Development Proposal – Application DA 2018/1828

RE: DA 2018/1828 – 3 Berith Street Wheeler Heights

Meeting Item 3.4 - DA2018/1828 – 3 Berith Street, Wheeler Heights.

Figure 3: Public Transport Map for the Site Vicinity

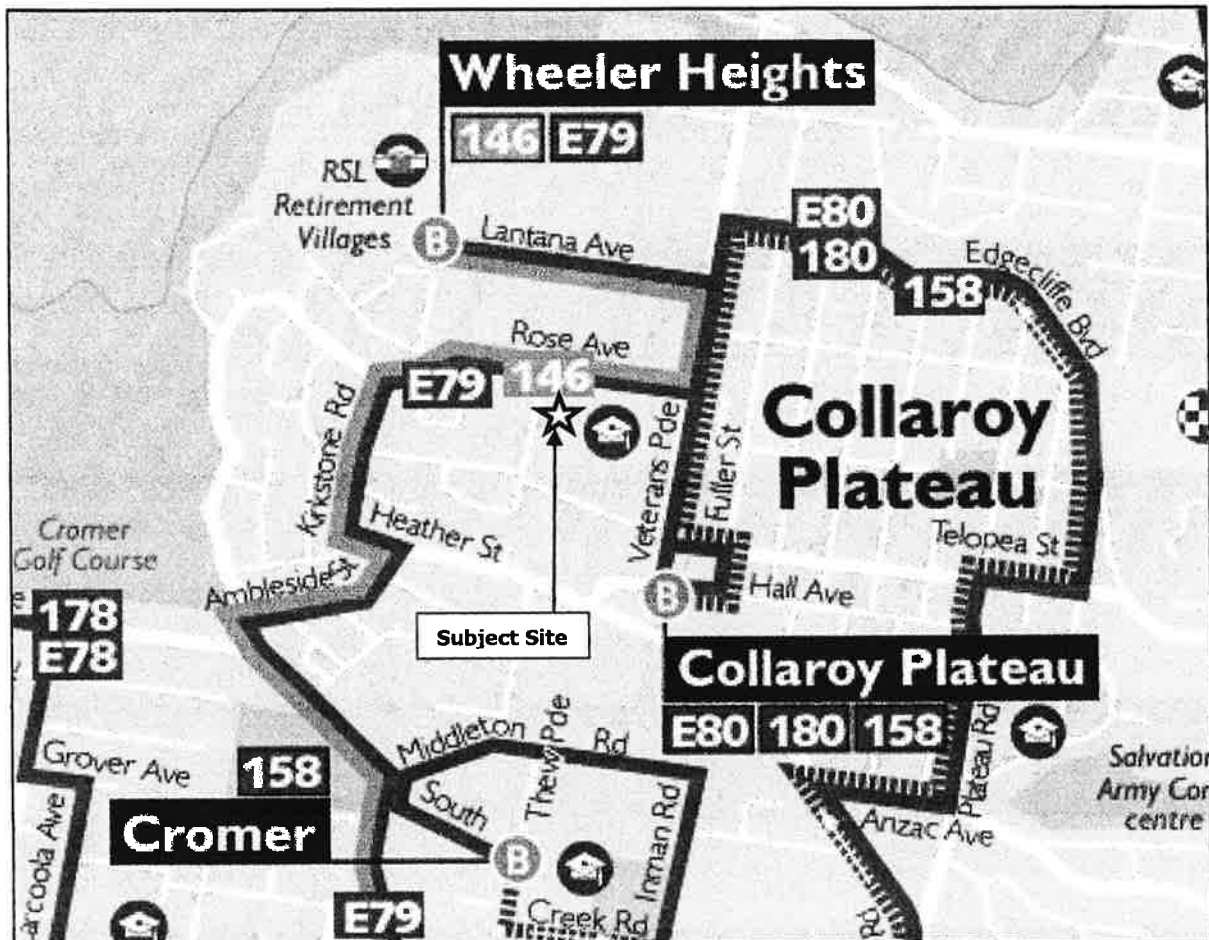
* Route 158 only does 1 trip per morning only weekdays
6:50 am Manly Wharf to Hall Ave, Collaroy Plateau
where it terminates

only does 1 trip in afternoon only on weekdays
4:07 pm from Manly Wharf to Croner

Neither of these 2 bus trips come into
Wheeler Heights

The morning trip from Manly is only 2 stops from the Veterans Parade Shops till it terminates in Hall Avenue.

PRELIMINARY GEOTECHNICAL ASSESSMENT FLOW CHART

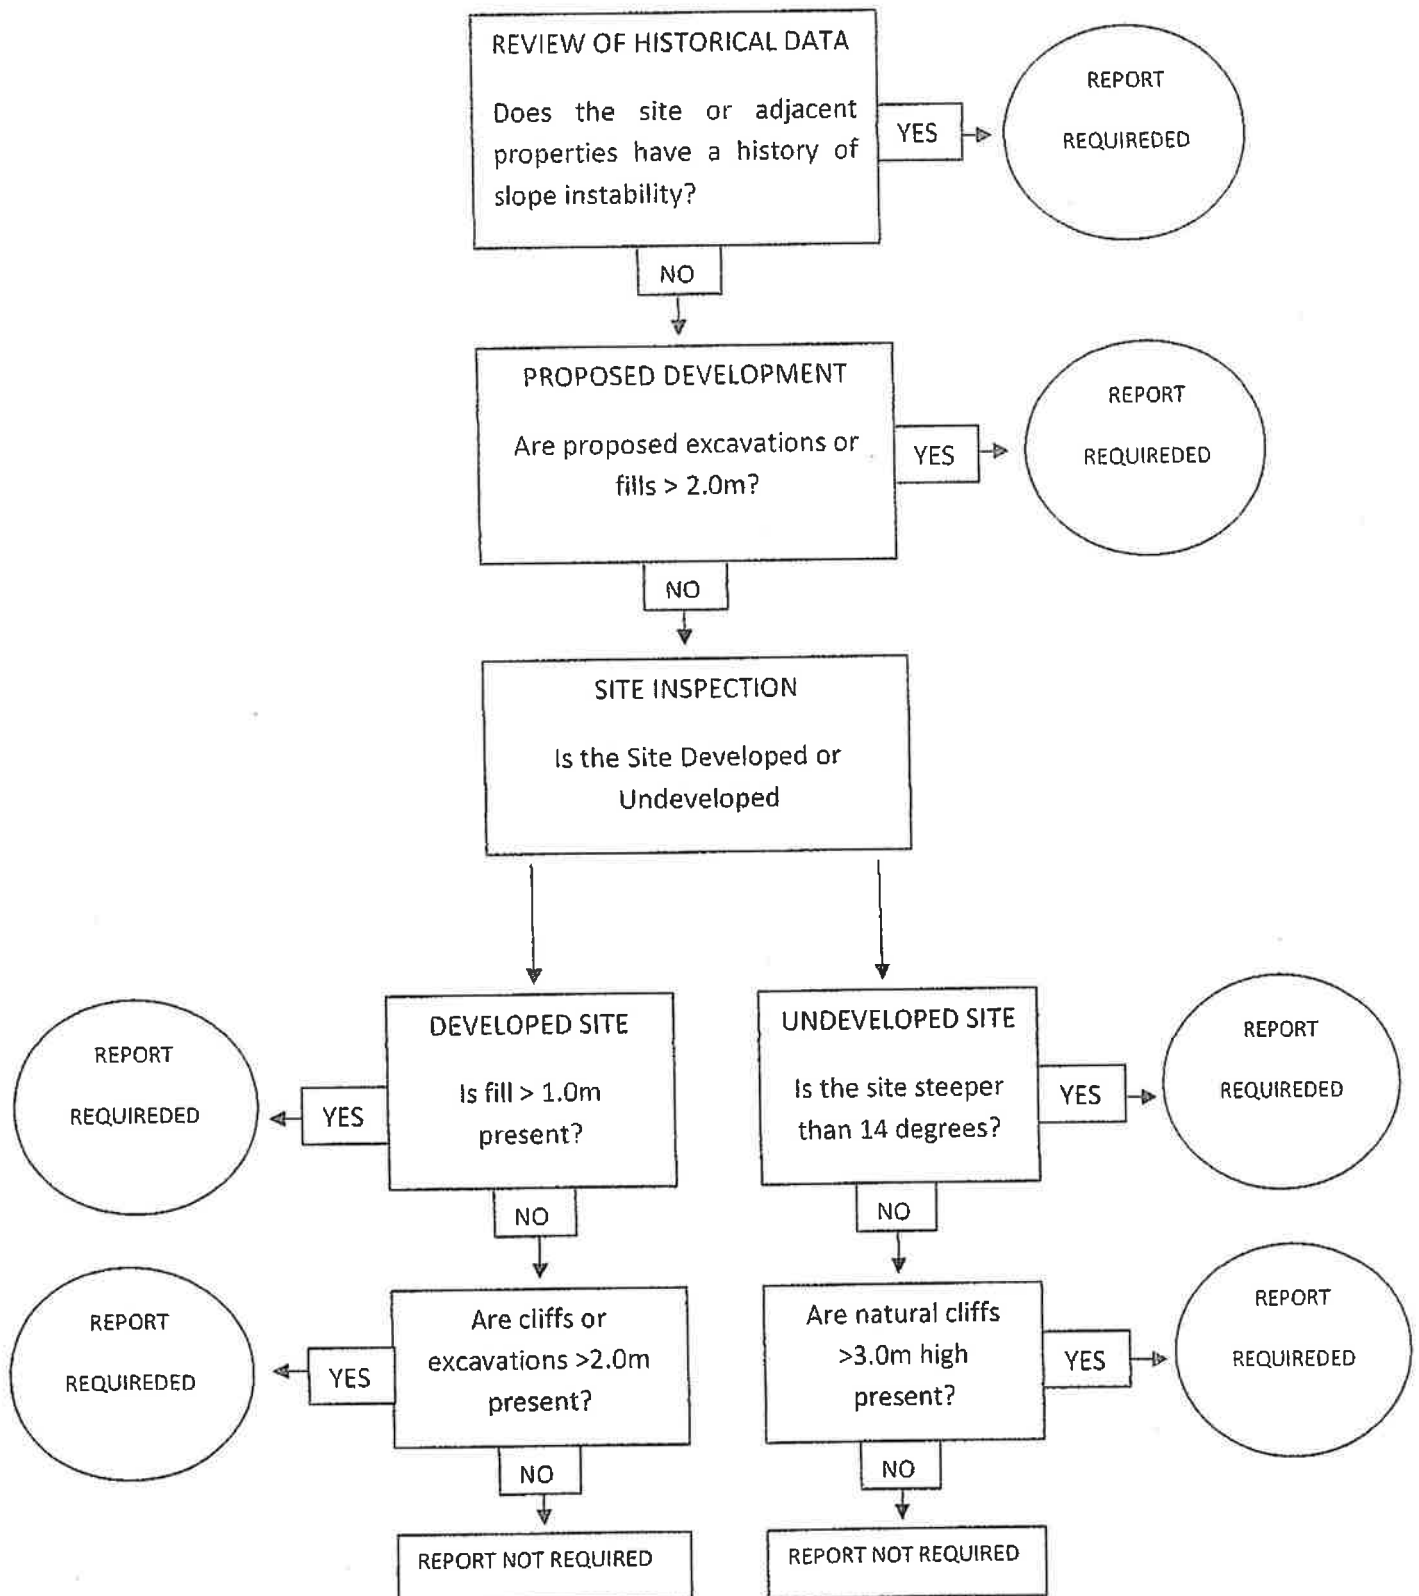
Page 3 of Report

Question: Proposed development

Are proposed excavations or fills > 2.0m answer now is yes.

This report has not addressed the current proposed development.
